SERVICE LETTER NUMBER 127			
TITLE: 8000 Nose Gear End Cap Cracks			
BY: J.SORTOR	AIRCRAFT MAKE/MODEL(S): N/A	FLOAT MODEL(S): 7000A/8000A	NOTE(S): MANDATORY COMPLIANCE S/L P/N 1005732 ECO--23055
APP: K. TAYLOR			
DATE: 11-DEC-12			
REV: B

All Model 8000A Amphibious Floats up to and including Serial No. 80398

All Model 7000A Amphibious Floats up to and including Serial No. 70030

FIGURE 1

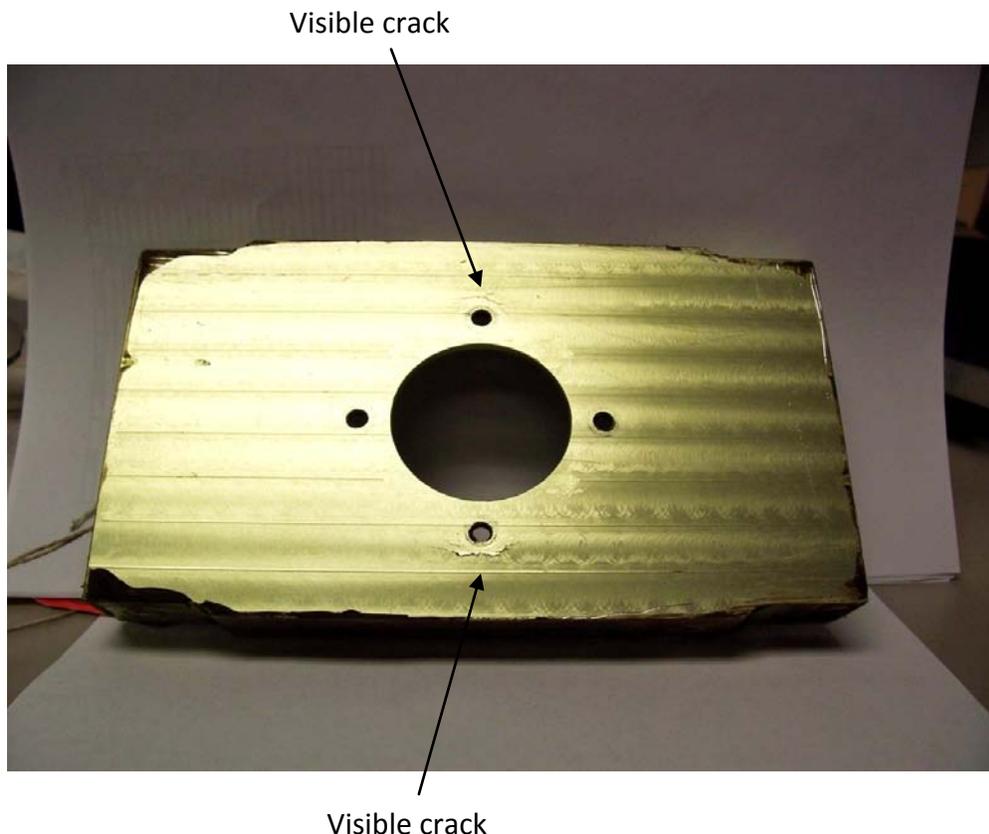
Several Nose Gear Box End Caps, part #8A07201-002 have been found to have cracks propagating from around the Cylinder Mounting Flange bolts (4). If these cracks go undetected there is a possibility that the End Cap, Part #8A07201-002 can break and let the actuator cylinder move to the selected gear position and the gear position lights indicate that the selected gear position has been reached when it has not.

A close visual inspection must be accomplished within the next 25 hours of operation, and every 50 hours thereafter. The cracks will be best visible by looking at the forward face of the End Cap, Part #8A07201-002 through the forward open end of the Nose Gear Box. It appears that the cracks start just above the top mounting bolt and just below the bottom mounting bolt as shown in Figure 1. If cracks are found the End Cap Part #8A07201-002 must be replaced with the new revision, End Cap, Part #8A07201-002, Revision F, dated May 2, 2012 or later. After inspection and/or replacement, re-adjust the gear "down" over-center lock so that it hits the end of the lock-up track has little to no preload pressure on it since the preload pressure would cause extra stress at the Cylinder Mounting Flange and the End Cap.

NOTES: The following figure 1 shows part that is cracked and figure 2 item 1 shows its location on the nose box assembly. This is the forward side of the part which can be seen looking into the open (front) end of the nose gear box. No disassembly should be required to examine this area. The area should be thoroughly cleaned before inspecting. Use good lighting. If in doubt, dye penetrent inspection can also be accomplished.

Replacement of the older revision parts with revision E parts will eliminate the requirement for 50 hour interval inspections, but this inspection should still be accomplished at 100 hour intervals thereafter. Revision E parts will be made easily distinguishable by adding flats to the top and bottom of the previously round center clearance hole.

If evidence of cracking is found in Nose Box End Cap either by visual or dye penetrant inspection per figure 1, the following instructions will be accomplished to replace damaged Nose Box End Cap:
